UNITED STATES PATENT AND TRADEMARK OFFICE

APPLICATION NO.	FILING DATE	FIRST NAMED INVENTOR	ATTORNEY DOCKET NO.	CONFIRMATION NO.
10/701,515	11/06/2003	Said I. Hakky	MR2493-38	7376

Office Action Summary	Application No. 10/701,515	Applicant(s) HAKKY ET AL.	
	Examiner Michael G. Bogart	Art Unit 3761

DETAILED ACTION

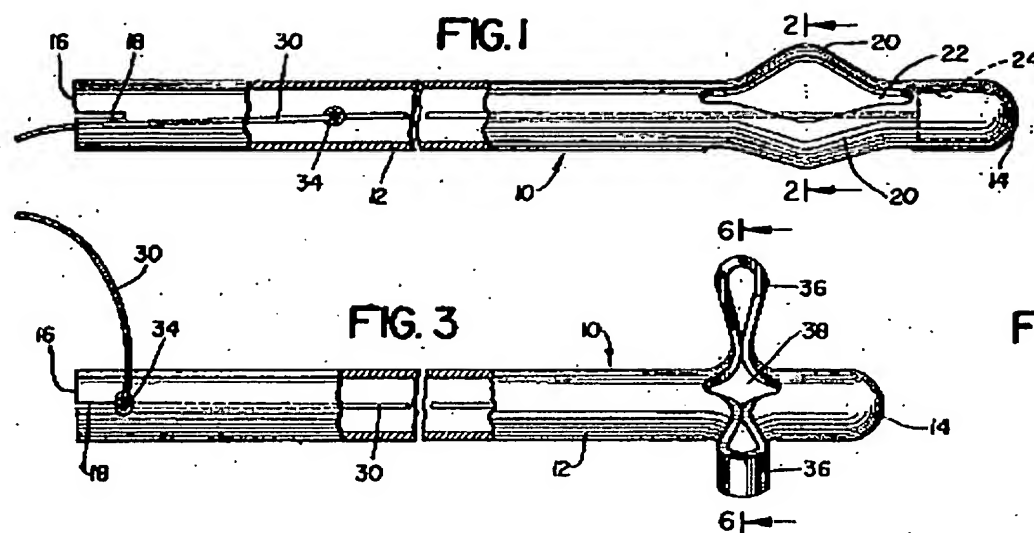
Claims 1-3, 7, 8 and 12 are rejected under 35 U.S.C. § 102(b) as being anticipated by Wallace (US 2,649,092).

Regarding claim 1, Wallace teaches a self-retaining urinary drainage catheter system (10), comprising:

(a) a longitudinally extending flexible tube (12) having a predetermined outer diameter, an open distal end (16) and a closed proximal end (14), said flexible tube (12) defining at least one lumen, said closed proximal end (14) having a plurality of longitudinally directed slits (22) formed through a wall of said flexible tube (12) defining a plurality of flexible tube (12) slit portions (20, 36); and,

(b) means (30) for reversibly and radially displacing said plurality of flexible tube slit portions (20, 36) of said proximal end (14) to a first configuration (fig. 1) abutting in a non-continuous manner an inner surface of a urinary bladder, said first configuration of flexible tube slit portions (20, 36) having an outer diameter greater than said predetermined diameter of said flexible tube (12) and defining a plurality of drainage apertures (38), and for displacing said plurality of flexible tube slit portions (20, 36) to a second configuration (fig. 2) wherein said plurality of flexible tube slit portions (20, 36) has a diameter substantially equal to said predetermined outer diameter of said flexible tube (12), wherein said means (30) do not substantially obstruct a lumen of said catheter (10), and said catheter (10) is reversably insertable in a human being without using a stylet (see figures 1 and 2, below).

Regarding claims 2 and 8, Wallace teaches that said means (30) further comprises a wire control device (30) longitudinally and slidably positioned within a lumen of said longitudinally extending flexible tube (12), said wire control device (30) fixedly secured at a first end (32) to an inner surface of said closed proximal end (14) and having a length greater than a length of said longitudinally extending flexible tube (12) so that a second end of said wire control device (30) protrudes through said open distal end (16)(figure 1).

Regarding claims 3 and 12, Wallace teaches that said wire control (30) device further comprises a means (18, 34) for reversibly locking said wire control device (30) in a predetermined position (figure 3).

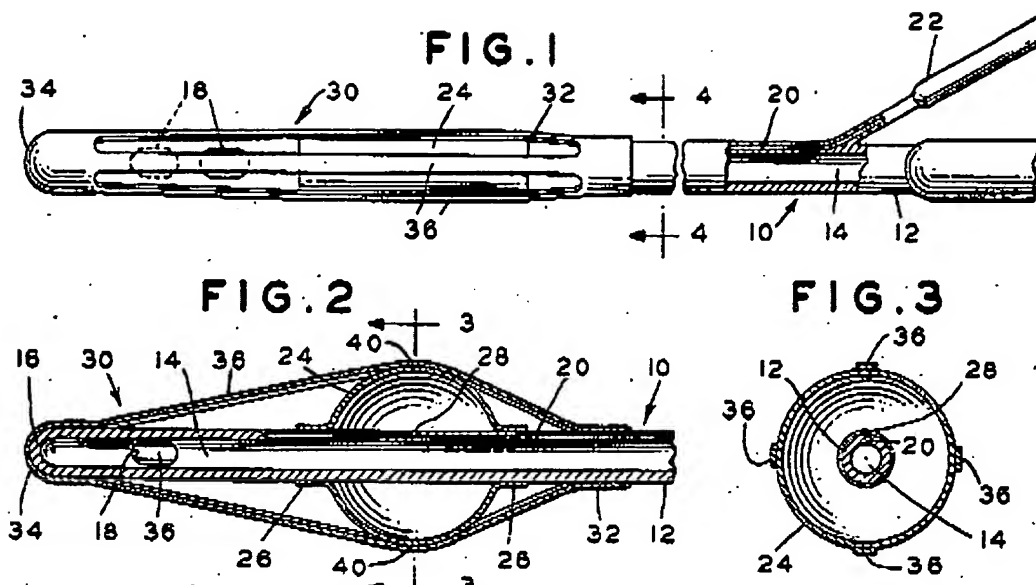
Claims 1 is rejected under 35 U.S.C. § 102(b) as being anticipated by Baskin (US 2,854,983.

Regarding claim 1, Baskin teaches a self-retaining urinary drainage catheter system (10), comprising:

(a) a longitudinally extending flexible tube (12) having a predetermined outer diameter, an open distal end and a closed proximal end (34), said flexible tube (12) defining at least one lumen (14), said closed proximal end (34) having a plurality of longitudinally directed slits (32) formed through an outer wall of said flexible tube (12) defining a plurality of flexible tube slit portions (32); and,

(b) means (20, 24) for reversibly and radially displacing said plurality of flexible tube slit portions (32) of said proximal end (34) to a first configuration (fig. 2) abutting in a non-continuous manner an inner surface of a urinary bladder, said first configuration of flexible tube slit portions (32) having an outer diameter greater than said predetermined diameter of said flexible tube (12) and defining a plurality of drainage apertures, and for displacing said plurality of flexible tube slit portions (32) to a second configuration (fig. 1) wherein said plurality of flexible tube slit portions (32) has a diameter substantially equal to said predetermined outer diameter of said flexible tube (12), wherein said means (20, 24) do not substantially obstruct a lumen (14) of said catheter (10), and said catheter (10) is reversibly insertable in a human being without using a stylet (see figures 1 and 2, below).

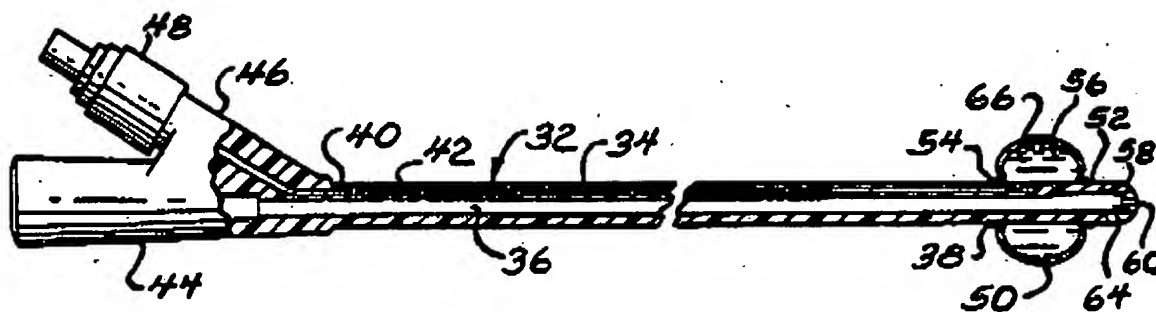
Baskin does not expressly disclose a valve.

Rosenberg teaches a balloon catheter (32) having a balloon inflation tube (42) that controls fluid flow to the balloon via a valve (48)(figure 6).

At the time of the invention, it would have been obvious to one of ordinary skill in the art to add the valve of Rosenberg to the fluid inflation tube of the catheter of Baskin in order to provide a means of keeping the balloon inflated.

Regarding claims 6 and 11, Rosenberg teaches an oblong balloon (50)(figure 6).
